What We Heard

Design refinements made as a result of previous public input.

Current Proposed Typical (May 2023 Public Meeting)

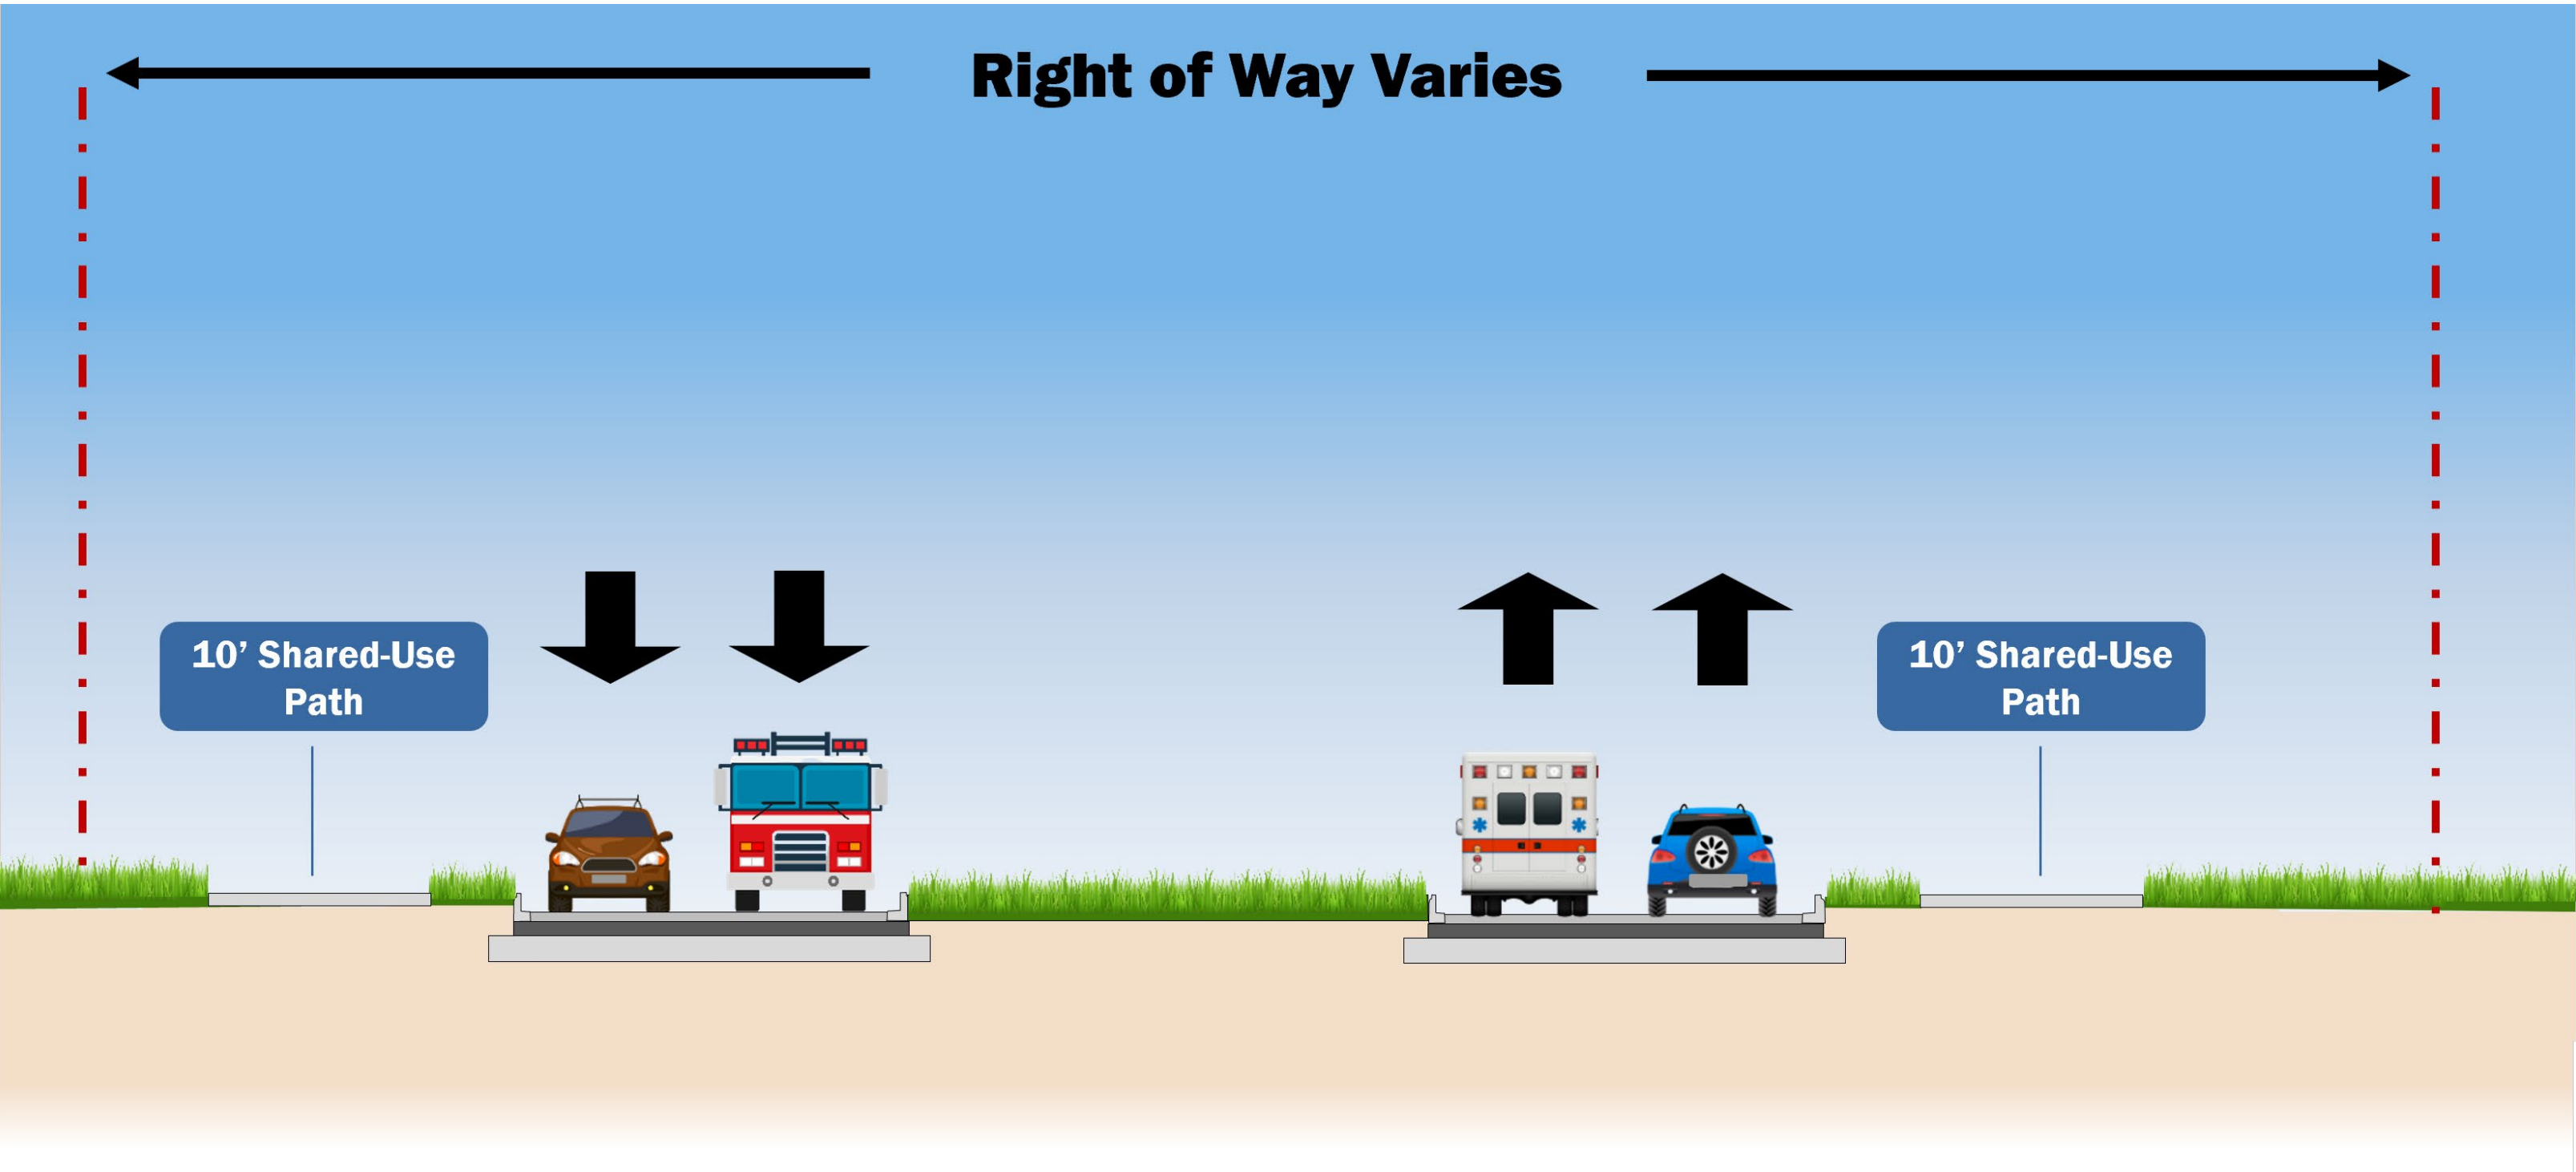
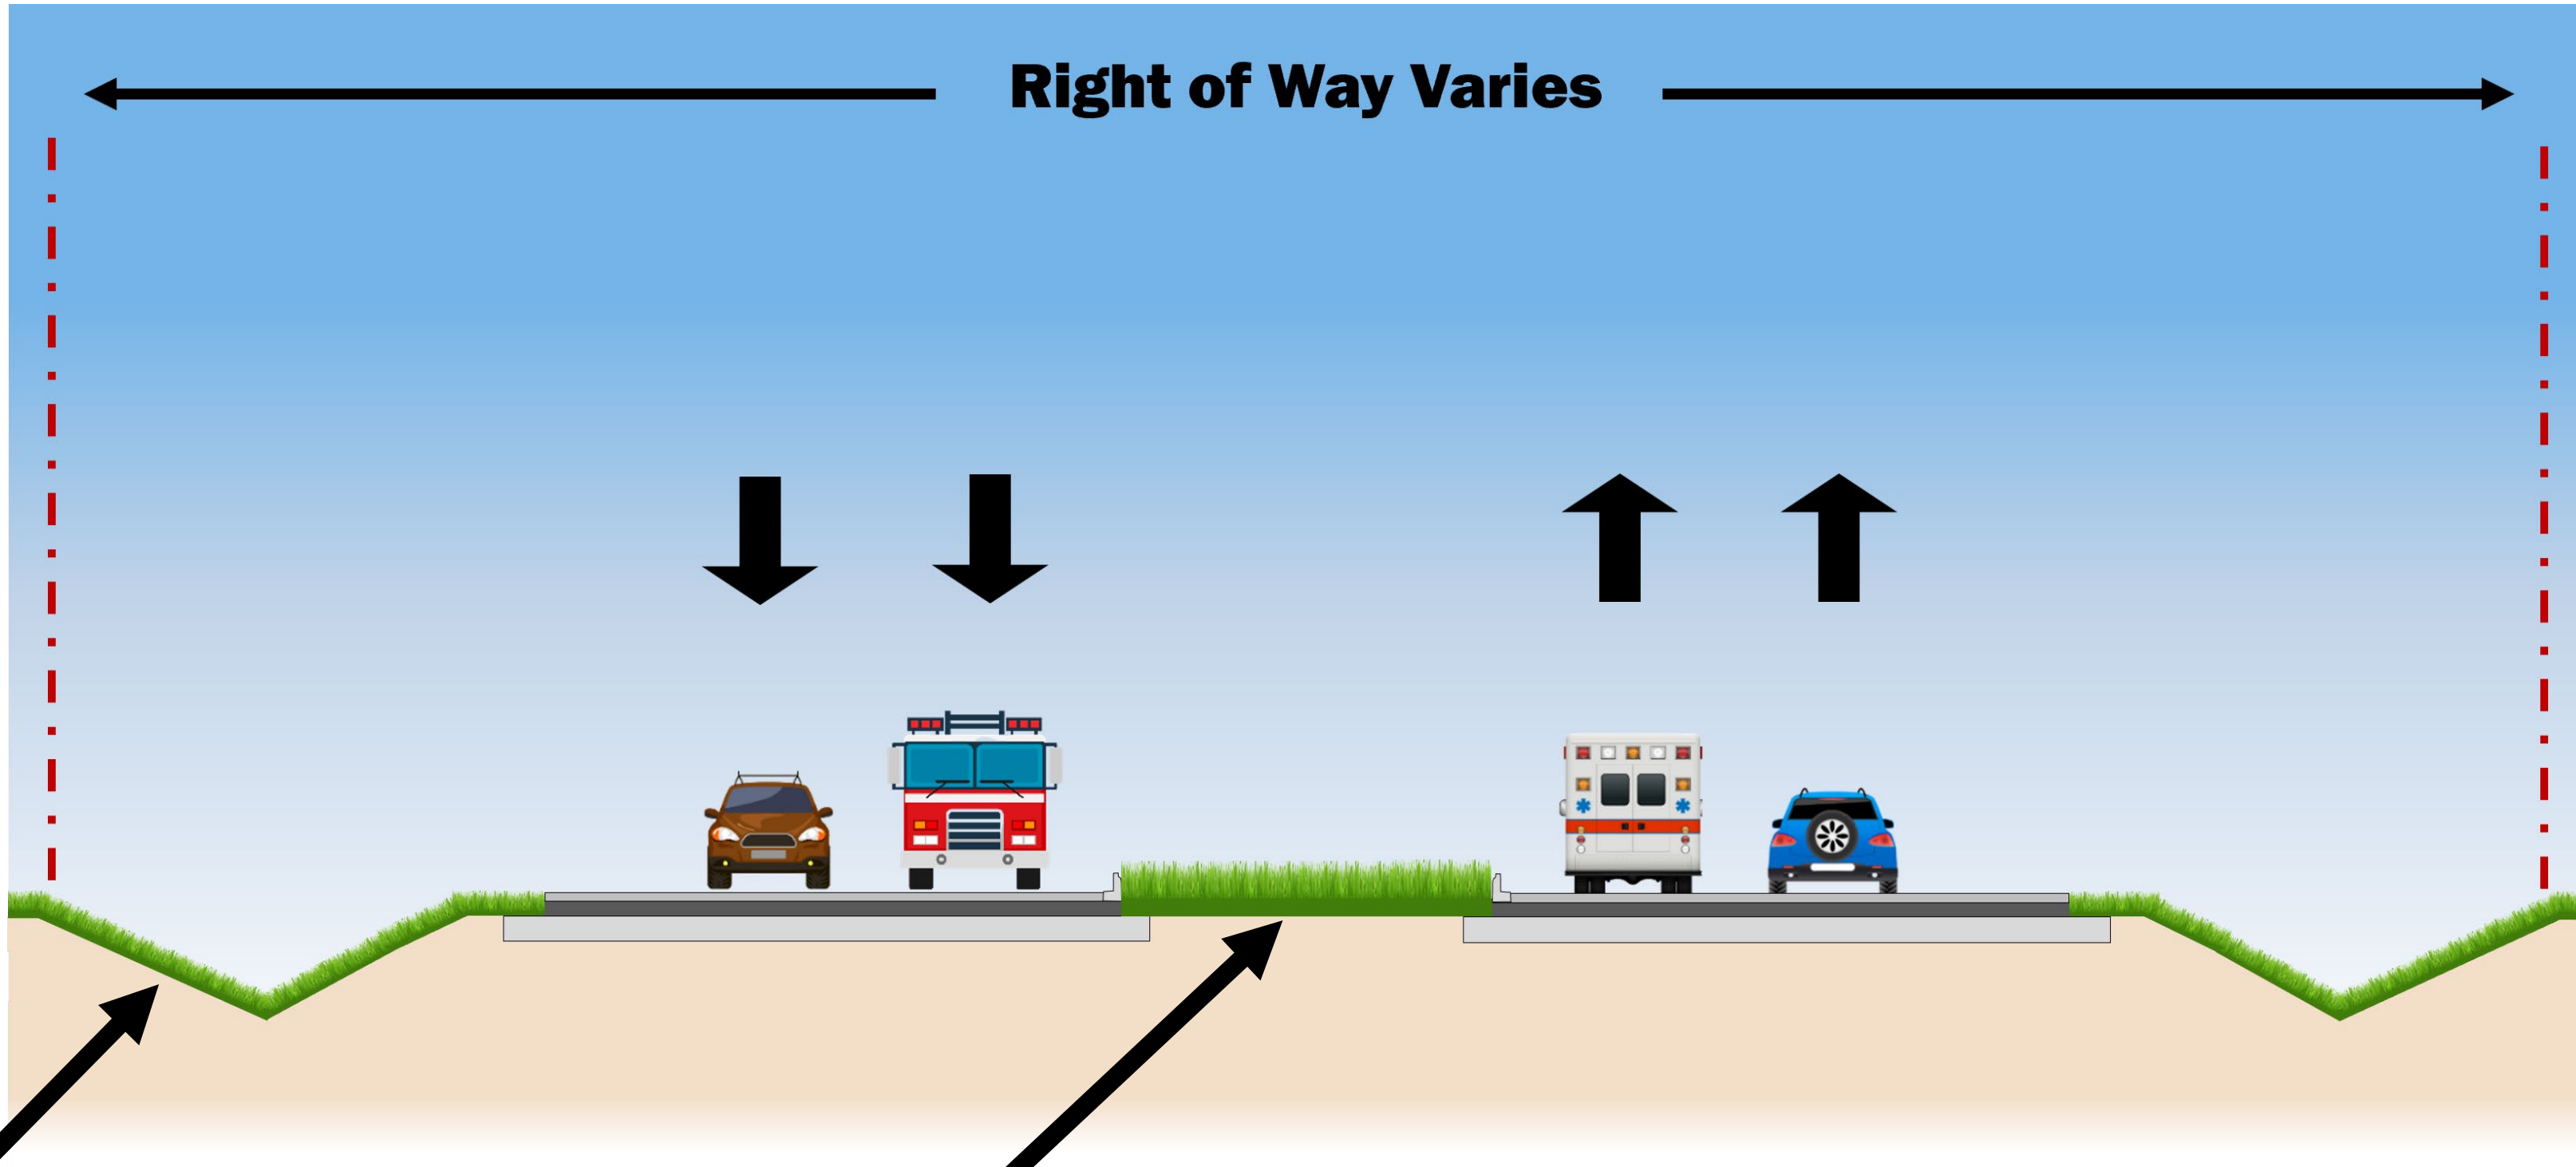
Rural look and feel to maintain the existing corridor – grassy ditches outside of widened roadway.

Decreased width of median.
